RESPONSES TO NRC QUESTIONS ON  
THE ROCS-DIT TOPICAL

CENPD-266

AMENDMENT 1-NP

February 1983

Figure 2-9b  
NEM-ROCS, RMS AND MAXIMUM PERCENT DIFFERENCES  
IN THE RADIAL POWER DISTRIBUTION vs PERCENT  
OF CORE HEIGHT

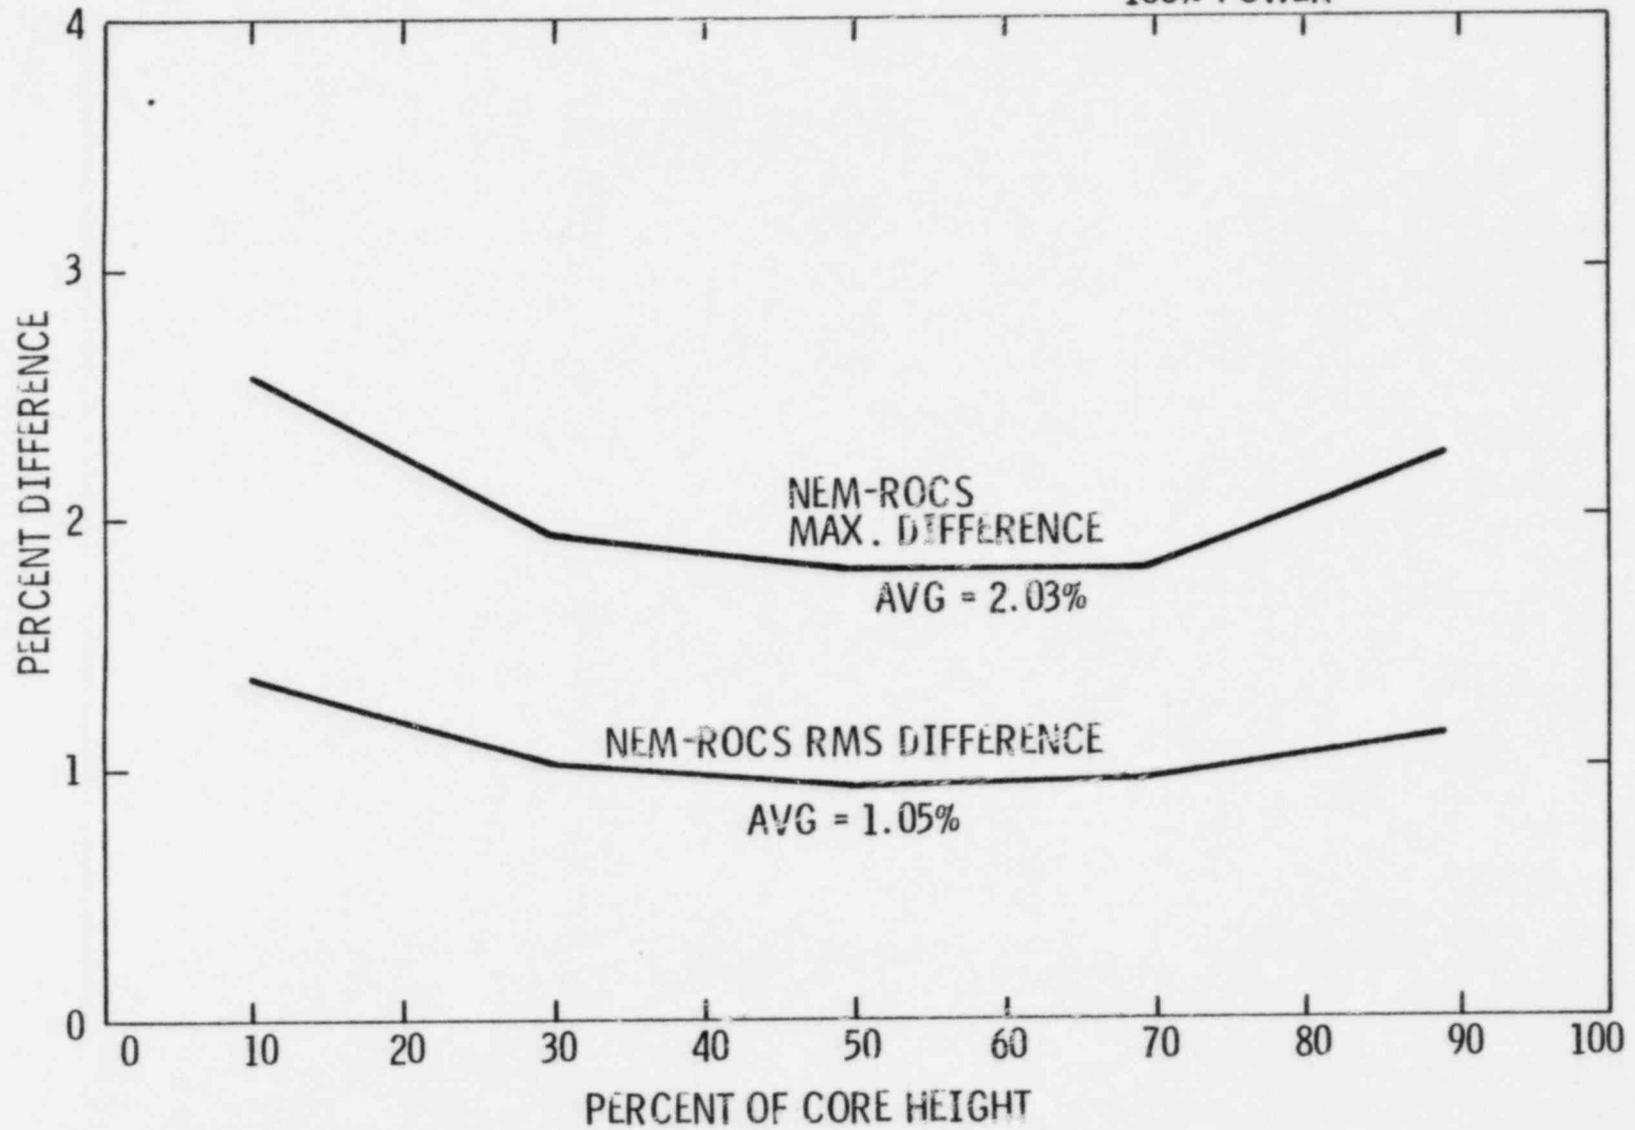
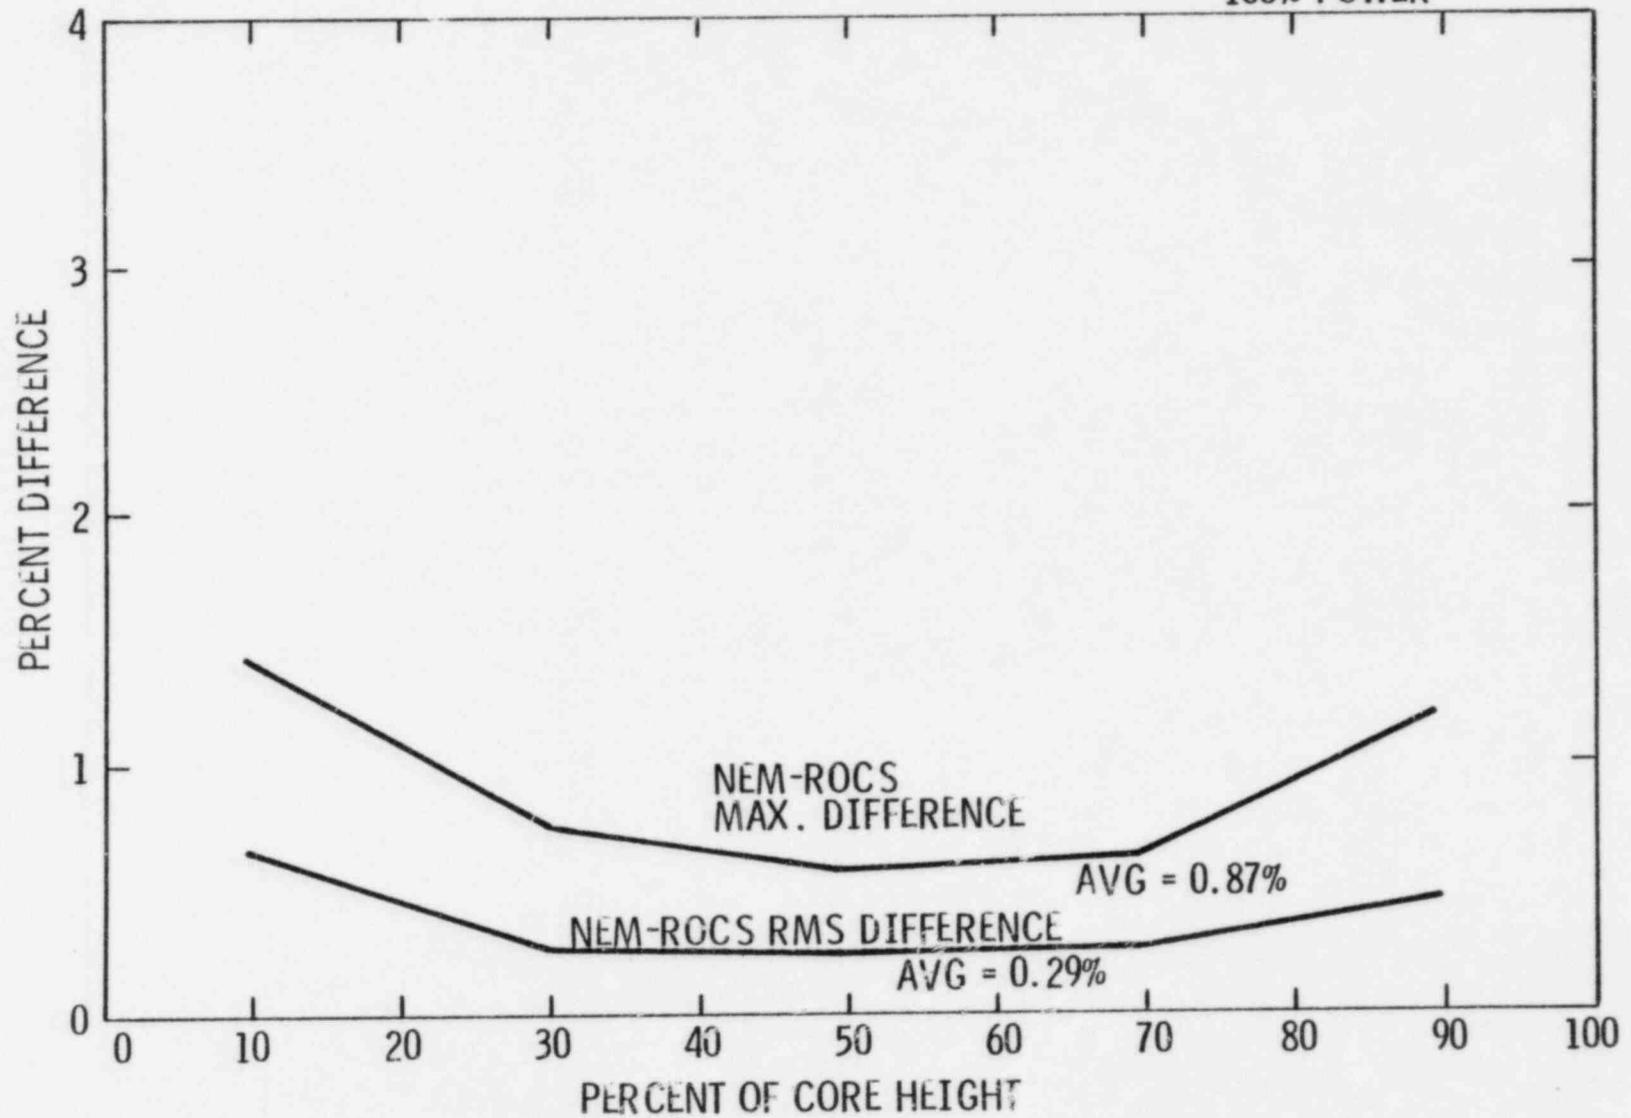
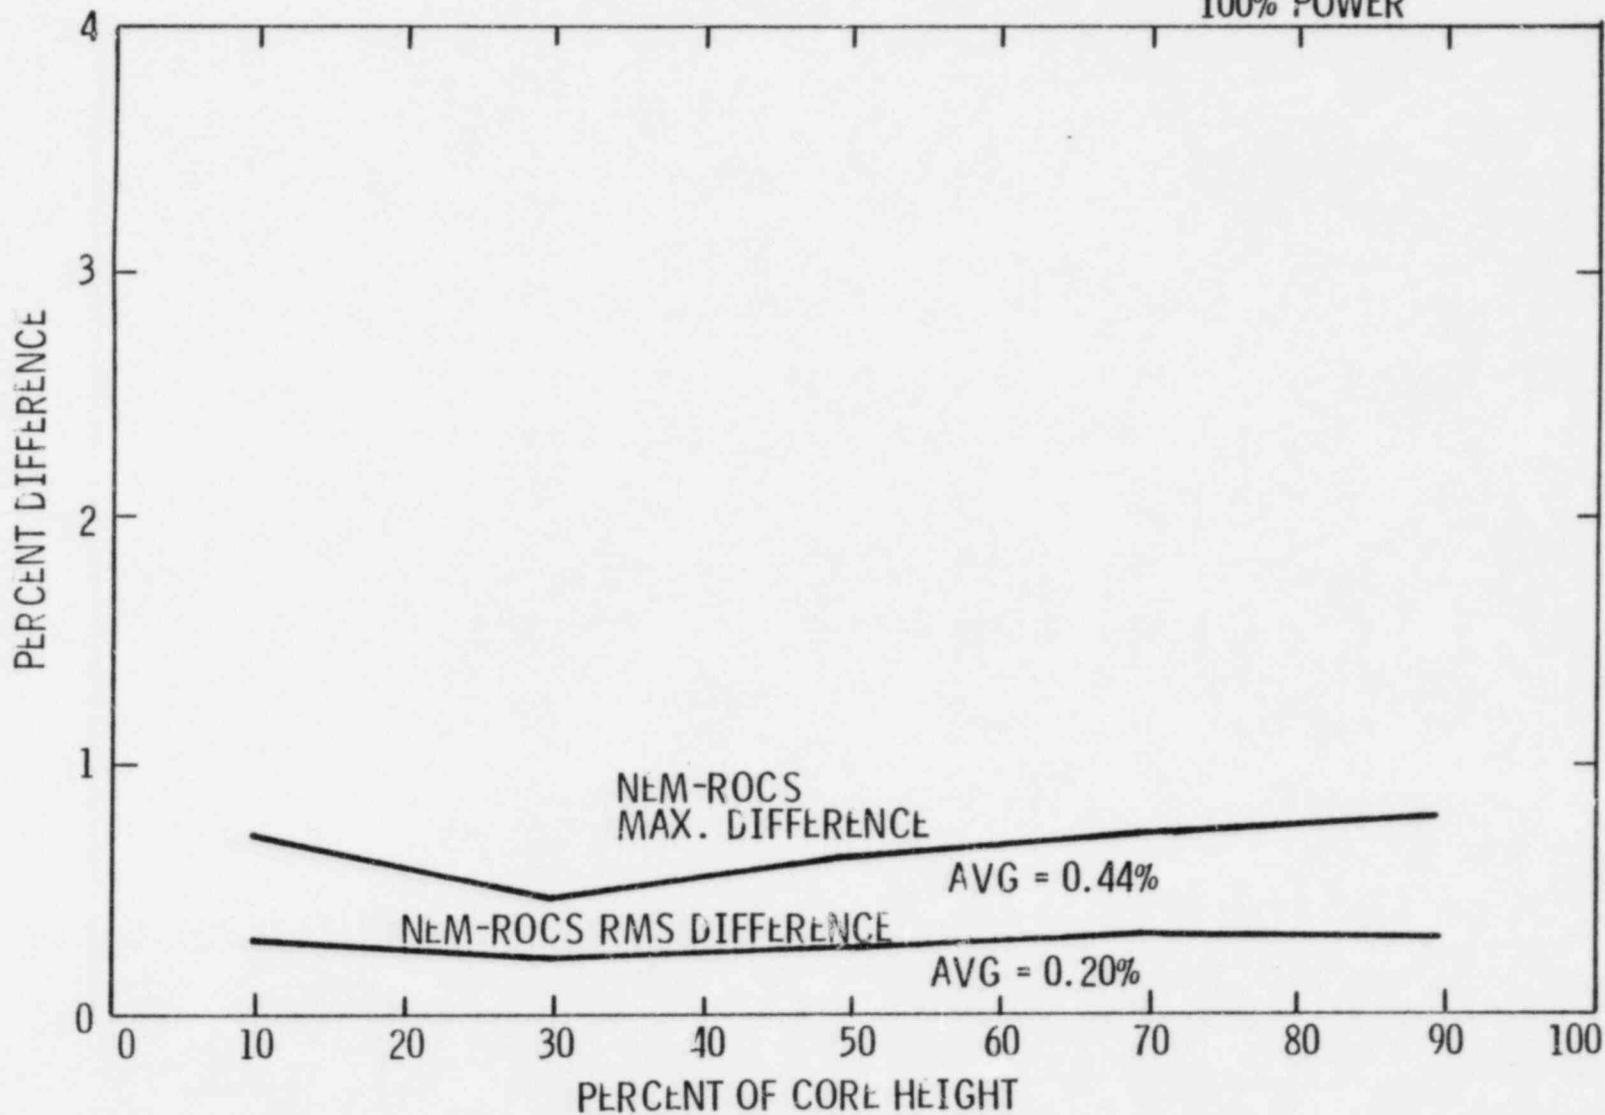
Further, rename the current Figure 2.9 as Figure 2.9a, and add Figures 2.9 b-e.

"Figures 2.9 a-d show the standard deviations and maximum errors resulting from these radial comparisons between NEM and HOD as a function of axial position and life. Maximum differences are on the order of [     ]."
